## > Product Change Notification (PCN)

**No.:** PN21-024

**Introduction of silicone center ring for SEMIPACK  
3 pressure contact modules**

**Subject of change:** Centering part of the chip stack

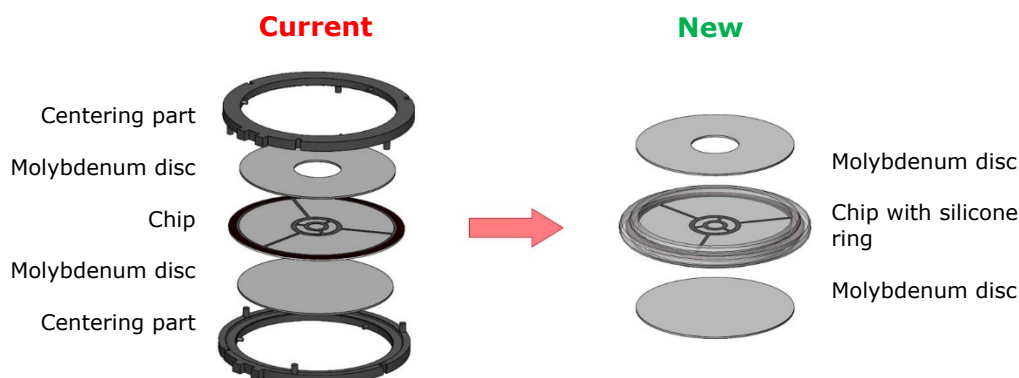
Change of the centering part of the chip stack

Replacement of the PPS rings holding the molybdenum and chip centered by one silicone ring:

<b>Reason for change:</b>	Unification with SEMIPACK 5 production line, production optimization
<b>Impact of change:</b>	No change of form, fit, function and reliability of the modules Change of the centering part material from PPS to silicone Update of Material Content Datasheet (MCDS)
<b>Identification of change:</b>	By date code
<b>Time schedule for change:</b>	Introduction of the new part in the production not before CW 34/2021
<b>Last time order date:</b>	-
<b>Last time delivery date:</b>	-
<b>Qualification:</b>	Concluded and passed in accordance with SEMIKRON standards
<b>Supporting documentation:</b>	Qualification report and the draft of updated MCDS upon request
